Pre-Lodgement Meeting Response

601 PACIFIC HIGHWAY

Council Advice		Architectural Response
COMMENTS 2.1 FSR	a) Minimum non-residential FSR	Justification Provided by Urbis
COMMENTS 2.2 Building Height	a) Plant levels - 8m/6m	Refer item 2.5-b for plant room strategy. The plant area has been allocated that is appropriate to achieve PCA-A grade level of servicing.

Section A - Mitchell Street Plaza frontage section

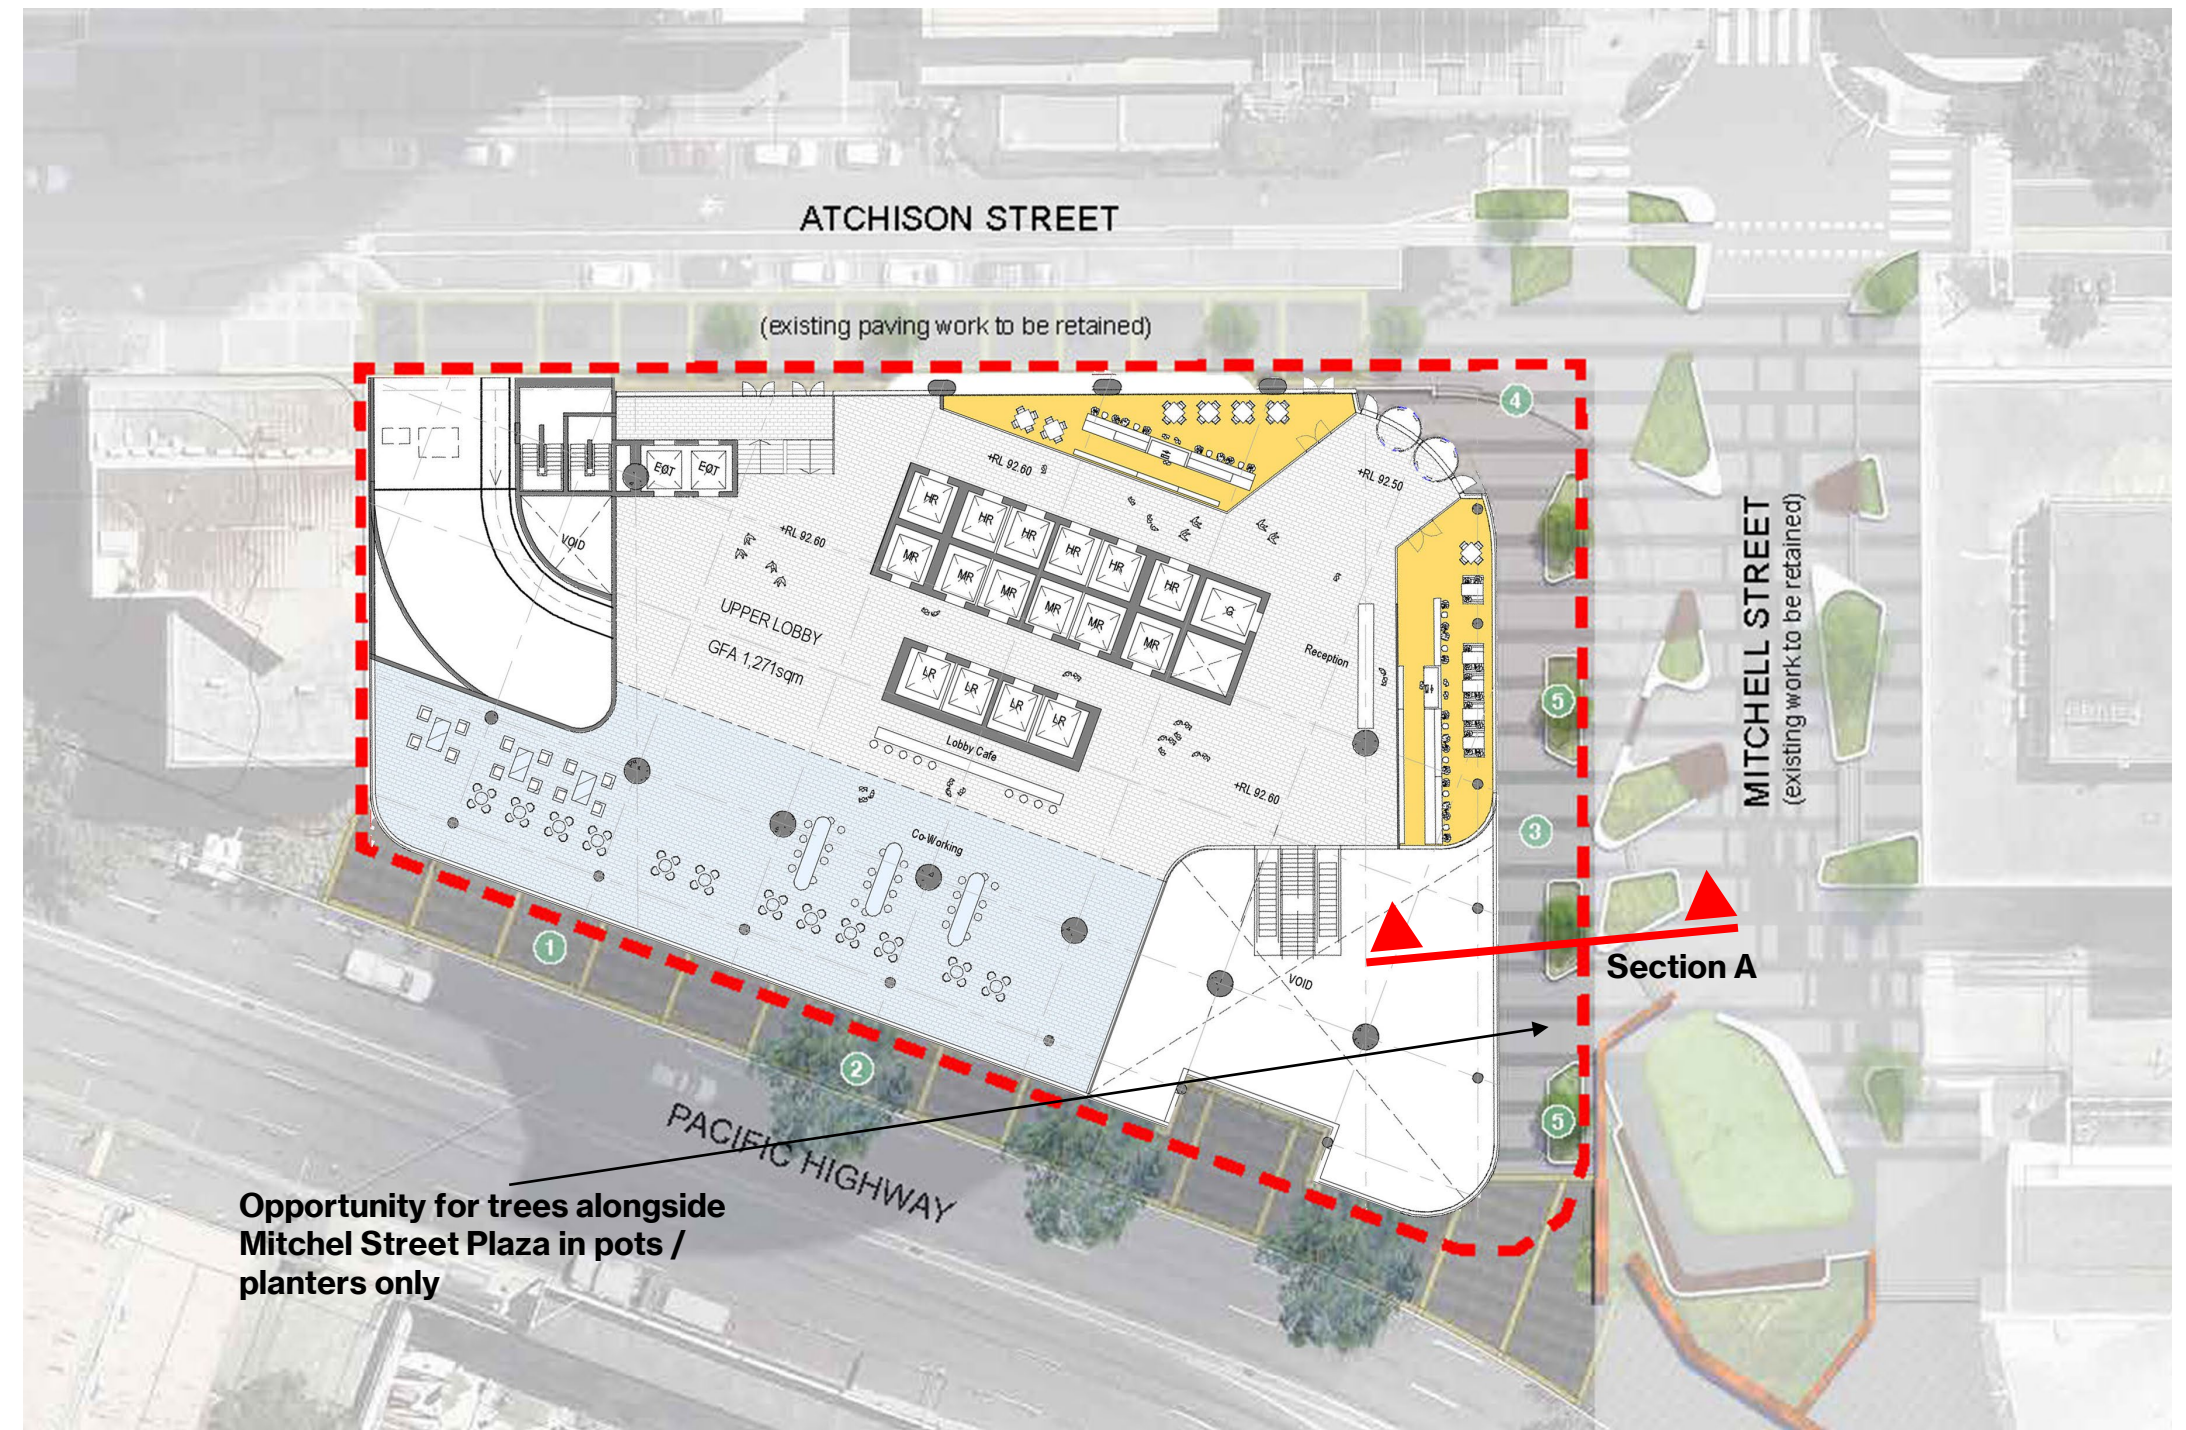
b) Street trees along Mitchell Street Plaza	Refer Item 2.8b. The Amendment proposes trees / greenery along Mitchell Street Plaza in raised planters as justified in 2.8a and 2.8b.
COMMENTS 2.9 Driveway Access and Location	a) Driveway access via Atchison Street	Justification Provided by Urbis
COMMENTS 10 Wind modelling	a) Wind study identifying wind impacts between the site and the adjoining development at 617-621 Pacific Highway	To be concluded when Wind Analysis is finalised.

The proposed amendment can include trees along side Mitchell Street Plaza in a responded to Council's request to promote a "greener" Mitchell Street Plaza. This amendment will provide shade, amenity and a more aesthetically pleasant urban environment for pedestrians. As previously demonstrated, it is not possible to promote deep soil planting on Mitchell Street Plaza frontage due to the existing basement structure which is meant to be retained.

The plan to the left depicts the opportunity to include planting along Mitchell Street Plaza in pots or planters and is indicative only. The amendment is subject to further landscape design.
